## New improved function module for the popular ICS valve

*To meet the requests from our customers the one piece function module has been changed to make it possible to exchange some of the wearing parts instead of the whole module.*

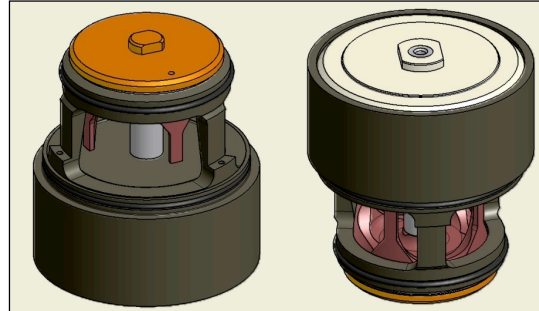
It has been a wish from some customers that it would be possible to exchange the Teflon seat because they experienced damage on the seat during start up due to dirt/welding particles in the system. We are therefore pleased that we have been able to make adaption to the product to accommodate this. With this change the whole size range from 25 to 150 can be serviced with the dedicated spare part kits.

The new design where the function module is screwed together also makes it more robust and serviceable in situations where it is used in very demanding applications like Economizer ports on screw compressors and in wet return lines of evaporators with Hot Gas defrost.

The prices and code numbers remain the same for the new and more flexible function module. There will be a transition time of approximately 3 months where both module types are available. If serviceable module is required please contact your local Danfoss sales office. Production start for the new function module is week 5 2012 and the product code/markings will be 0512 or higher.
